Meeting Date: Thursday 12 August 2021
Location: Meeting held remotely
Time: 5.00pm

2 79-81 Station Street, West Ryde

LDA2020/0439

City of Ryde Local Planning Panel Report

Figure 9 Proposed landscape plan

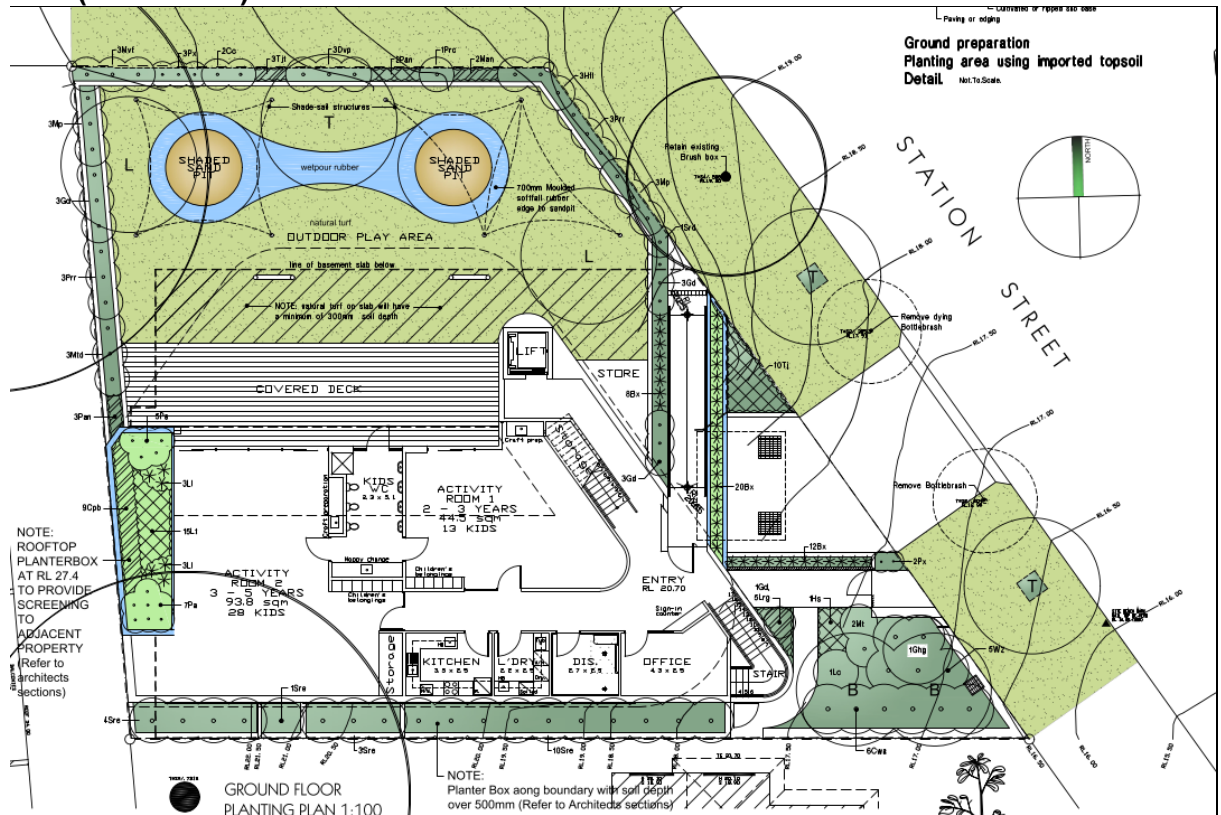
The submitted landscaping plans contains insufficient level details to accurately interpret the proposed development. The proposal includes a considerable cross fall in addition to extensive excavation works. The proposed design is required to provide levels, including spot levels and top of wall heights given the reliance upon changed levels throughout the site. The landscape design relies upon retaining walls along each boundary in addition to internal walls to create levels for the play spaces.

The proposal relies upon planter boxes within the reduced setbacks to achieve landscape screening between properties which is consistent with the landscape character of a low density residential area. Particular concern is held regarding the siting of the development within the south western corner and the relationship with adjoining residential properties.

Figure 10 Front Elevation (Station Street) Source Manor House Design

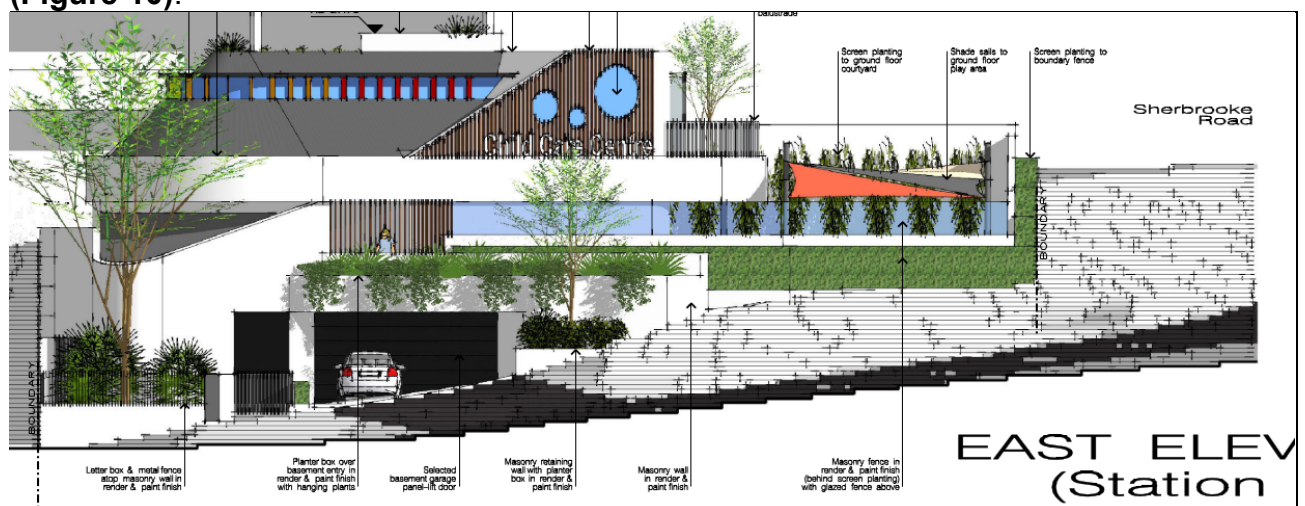
The retaining walls within the front setback contribute to uncharacteristic visual presentation to the streetscape, which is not responsive to the site's topography (**Figure 10**).

Figure 11 Cross section **Source Manor House Design**

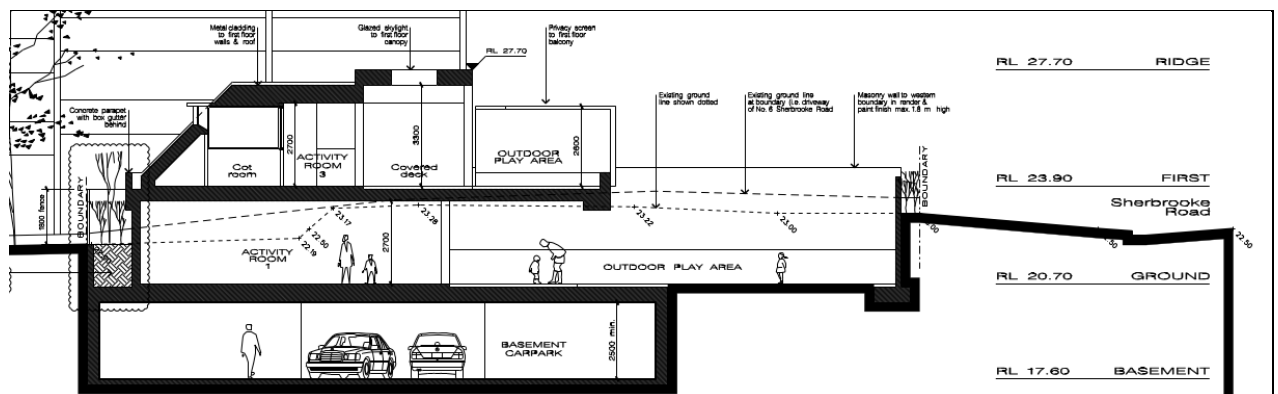
The proposal has been designed with the ground floor level being excavated at least 1.16 metres (**Figure 11**). The submitted plans notate a western wall height of 1.8m, however as a result of the excavated level of the play space has an enclosing western wall 2.96 metres in height. Additionally, the northern elevation of the play space contains a 2.7 metre wall resulting in poor amenity to the play space.

Figure 12 Cross section (setback along the western elevation shown) Source Manor House Design

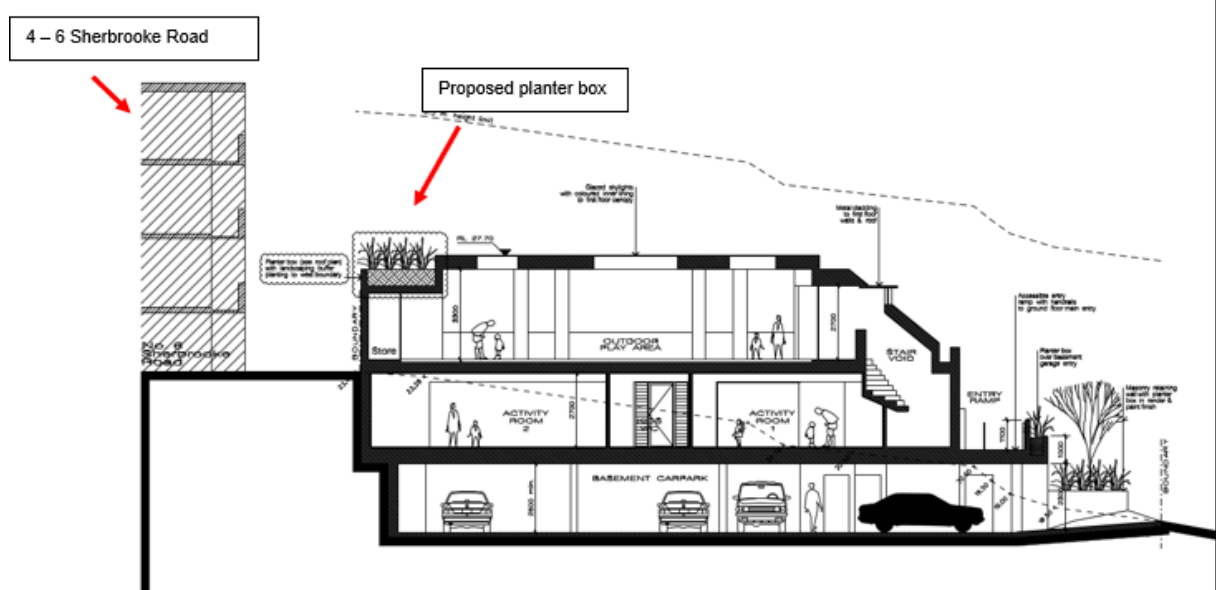
The proposal results in reduced setbacks along the western side boundary and the amended proposal has included a planter box. The proposal has a resultant wall height of 3.74 metres setback 50mm. The provided setback is not sufficient to accommodate a wall of this height given it immediately adjoins the balconies within 4 – 6 Sherbrooke Road (**see Figure 12**).

Due to the extent of the excavation required to create a level building platform, the outdoor ground floor play space will have a subterranean feel. Although, specific details have not been provided, it is calculated that retaining walls in addition to fencing result in a wall height of 2.96m along the western boundary and a height of 2.7m along the northern boundary.

Figure 12 Extent of excavation proposed Source: Manor House Design

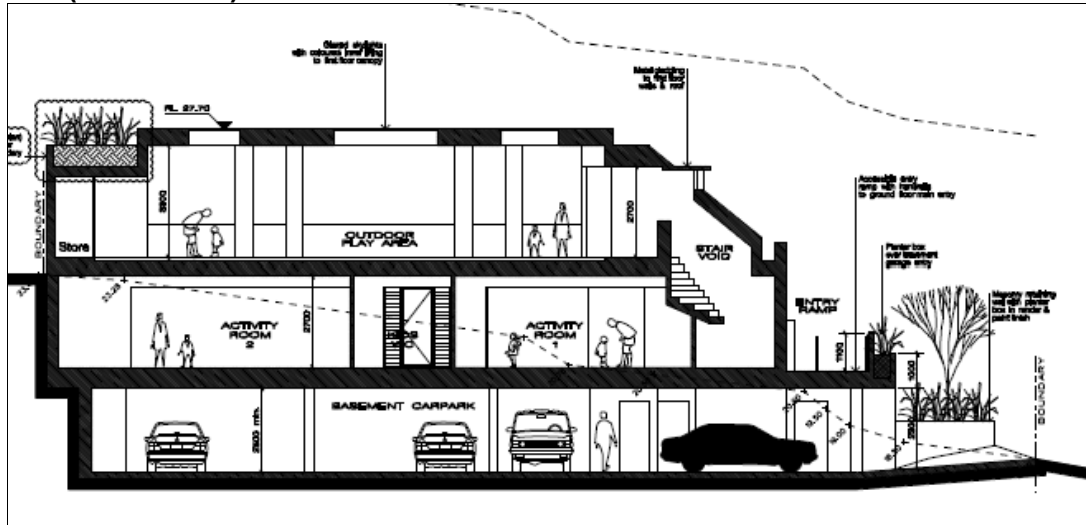
The scale and extent of earthworks required for the proposal which includes the ground floor level being excavated in addition to the proposed basement carpark will result in excavation to a depth of 5.68m (**Figure 13**). The extent of excavation does not have regard for the natural topography of the site, or the visual amenity of Station Street. Retaining walls will be required to be constructed within the front setback resulting in a loss of residential character, cohesion and amenity values. The low density, landscaped character of the public domain will not be maintained.

Figure 13 Street elevation Source: Manor House Designs

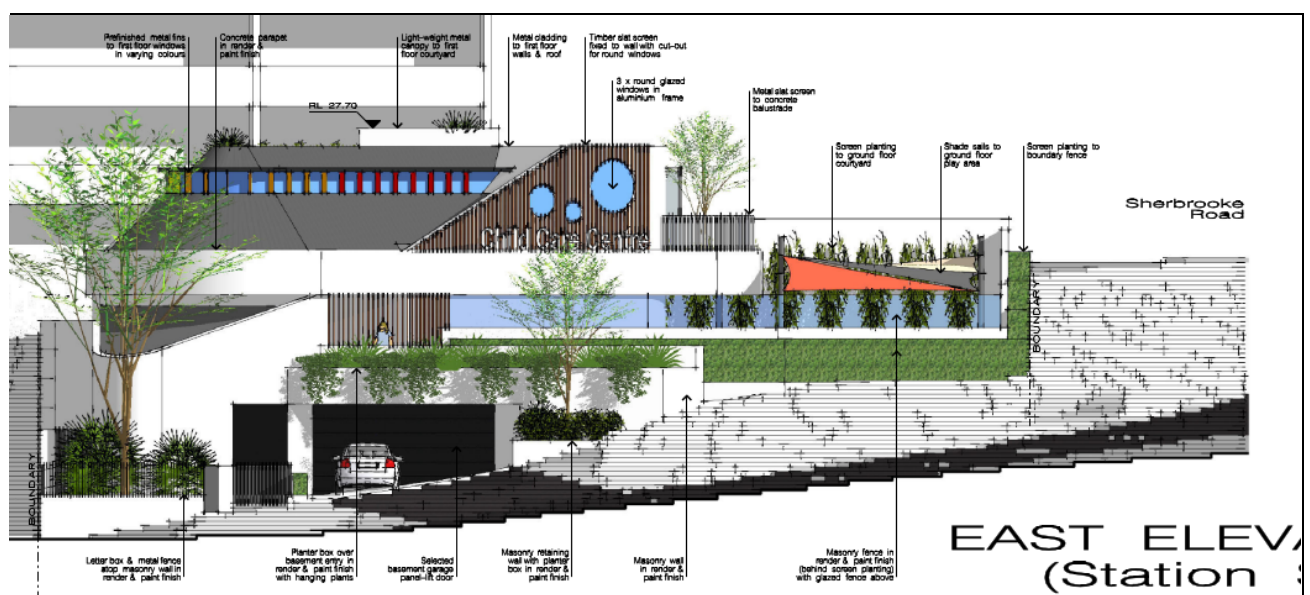
The proposal presents as a three storey building to Station Street (**Figure 14**). The proposal includes nil setbacks at the basement level for part of the eastern front boundary which limits landscaping opportunities in addition to the required retaining walls both along the eastern boundary and then to the north and south of the driveway in response to the created levels within the site. This results in retaining walls, pathway, planter boxes and ramp access within an already reduced landscape area. The purpose of a front setback within the low density residential area to provide a landscape setting, in which the proposal does not. The basement extends 26 metres across the 33.5 metre frontage and the siting of the ground and first floor and required ancillary elements results in a poor streetscape outcome.

Figure 14 Proposed wall on western boundary

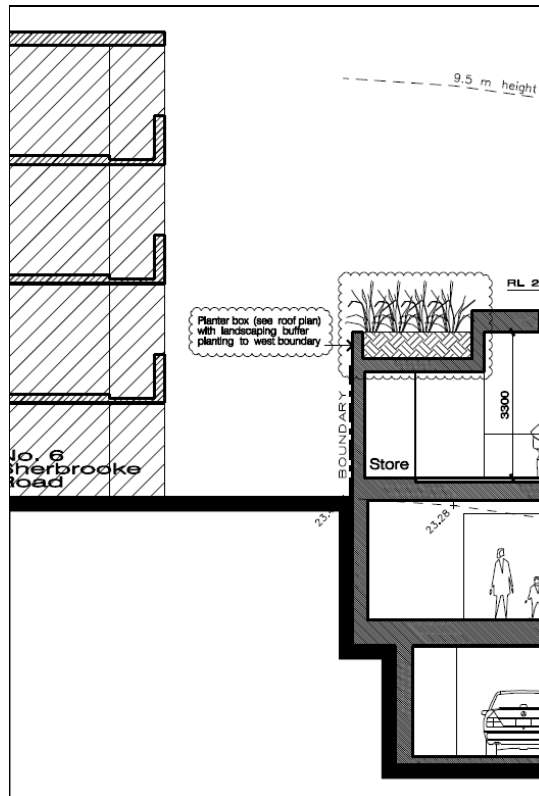
The proposal includes a 3.74m fence height along the western boundary shared with 4 – 6 Sherbrook Road (**Figure 15**). The wall immediately adjoins the eastern balconies and principal private open space of these dwellings. The proposal results in an unacceptable visual presentation as a result of the wall height and non compliant setback.
